**City of West Linn**  
**PRE-APPLICATION CONFERENCE MEETING**  
**SUMMARY NOTES**

**May 1, 2014**

Proposal: Landis Properties Subdivision (7 lots) with Class I and II Variances. (PA-14-24)

Location: 21E 36BA tax lot 6300 (4096 Cornwall Street)

### OPTION 1

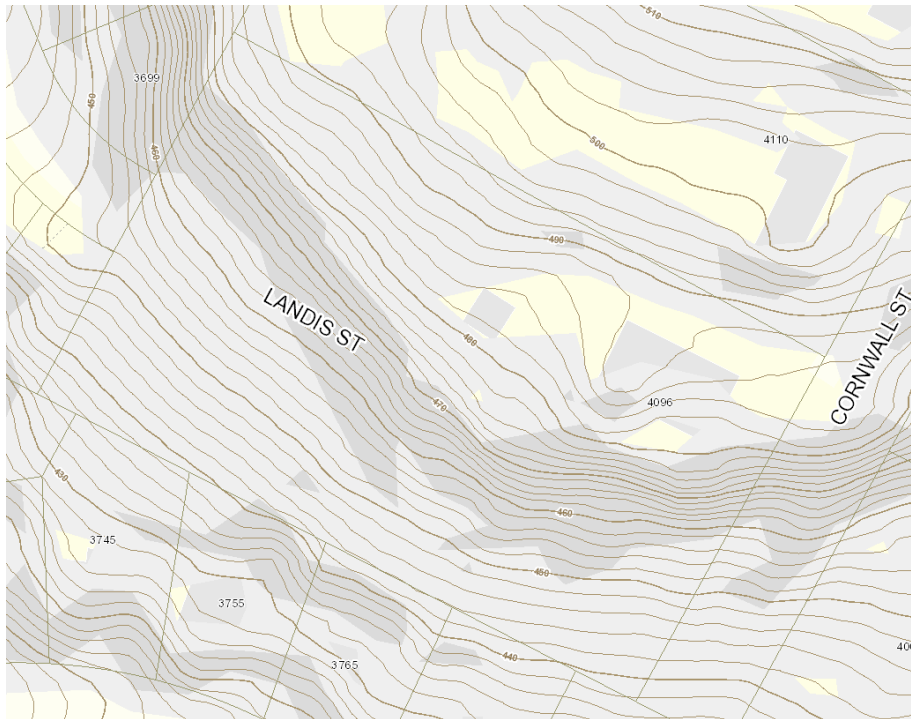
The applicant offers two design options with both showing Landis Street extending easterly through the site and connecting with the undeveloped Cornwall Street ROW. and the possibility of accessing tax lot 7701 to the east. The lots are all over 10,000 square feet except lot 3. The main difference between the options 1 and 2 is the access driveway to serve the northern tier of lots would be configured differently.

In addition to the subdivision application, a Class I Variance would be needed per 75.020(A)(2)(d) which allows deviation from the minimum lot size by up to five percent. Class II Variances would also be needed for the southern lots because of their inability to meet the minimum lot depth of 90 feet. A Planned Unit Development (PUD) may be required if more than 25% of site comprises 25% slope or greater.

The applicant seeks variances from the minimum lot depth and the minimum lot size (options 1 and 2). Staff could support the minimum depth variance but is not fully supportive of the variance on minimum lot size with a straight subdivision application. Based on the submitted subdivision drawings, lot 3 is right at, or close to, 10,000 square feet. It is only because the access easement runs behind that lot that it drops below the required square footage. Staff recognizes that the rear driveway idea eliminates the need for steep driveways to each lot off Landis Street. Staff also recognizes that if the driveway at the rear is denied, the applicant will be applying for four Class II variances for driveway grades over 15%. Driveway grades for the downhill lots may also trigger the need for Class II Variances.

The connection of Landis Street with Cornwall Street (option 3) will enhance connectivity in this area and help meet the Transportation Planning Rule. Options 1 and 2 will provide a connection to tax lot 7701 to the east but will turn Landis Street into a 1,150 foot long cul de sac when the maximum allowed length is 200 feet.

A more agreeable solution would be to apply for a Planned Unit Development (PUD). So long as the applicant meets the density calculations of 24.120, and there are no deductions for site conditions per section 24.130, the proposed seven lots would be allowed. Also, according to section 24.180(A), the PUD application would relieve the applicant from having to apply for all the variances.

### OPTION 3

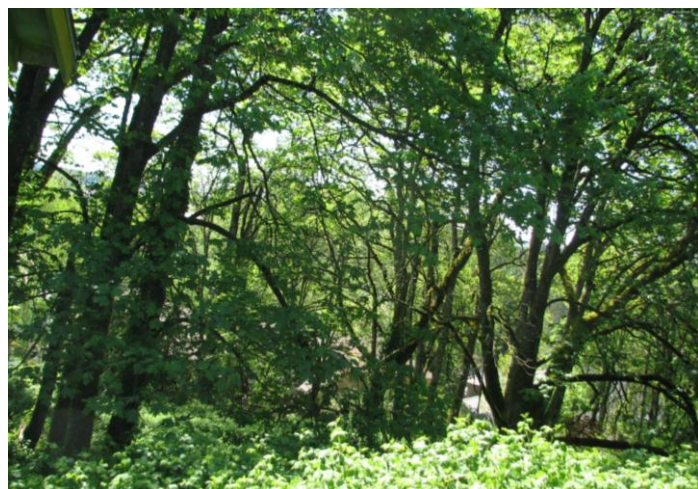
Staff's preferred choice is Option 3 which would connect Landis Street with Cornwall Street at the northeast corner of the site. The advantage of this alignment would be that it avoids or minimizes exposure to the steep grades near the lower section of the Cornwall Street ROW. It would also provide a physical connection of the streets. The challenge of this design would be accessing tax lot 7701 to the east of the subject parcel (4003 Cornwall Street). This option is also proposed as a PUD with the possibility that it could be developed in a similar fashion to Tanner Stonegate subdivision to the west.

Two foot contour intervals with darker shaded area representing 25% slopes or greater

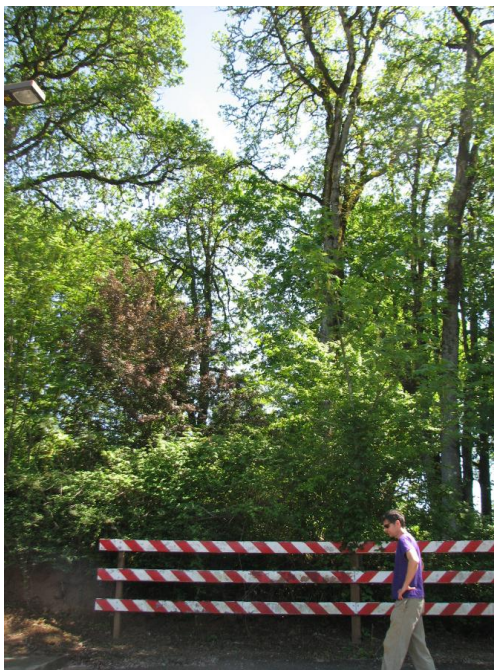
The site comprises a vacant hillside that slopes down from northeast to southwest at 22 percent on the west edge of the property and at a very steep 29 percent near the Cornwall Street ROW. The steepness of the east portion of the site was amplified during the site visit. Although the City hazards map and DOGAMI maps do not identify any on-site slope failures or similar hazards, a geotechnical report would be appropriate plus a discussion of drainage.

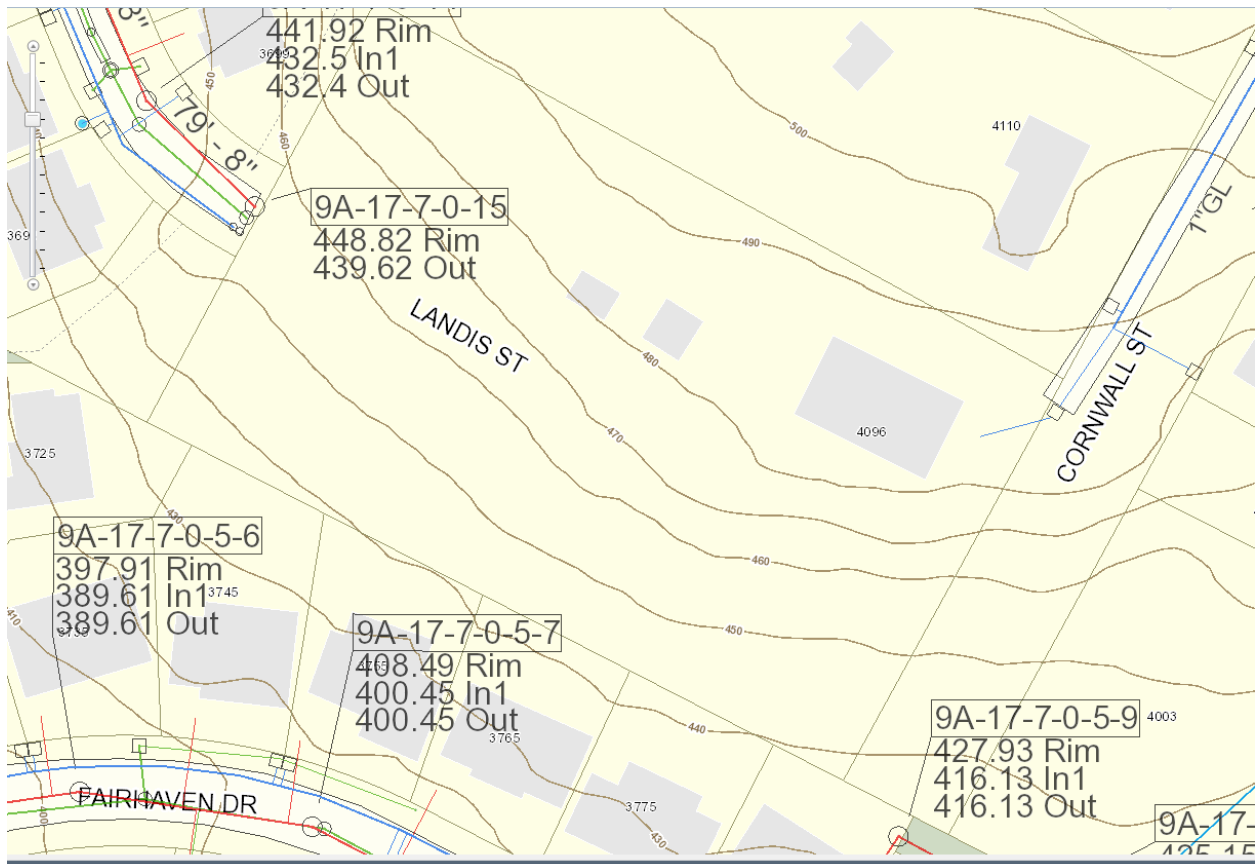
Existing public water system is available on Landis St for connection.

Existing public water system is also available on Cornwall St for connection.

1. Existing public water system is available on Landis St for connection.
2. New water system must be looped. Existing main on Cornwall St is currently sub-standard. This system must be upgraded prior to allow connection. Upgrading of this system can be done by City or Developer. Developer will get full reimbursement.
3. New water meter shall be set behind curb and out of driveway approaches. No water meters or water main shall allow to be placed in private drive way.
4. As-Built: Tanner Stonegate and Tanner Creek Estate.
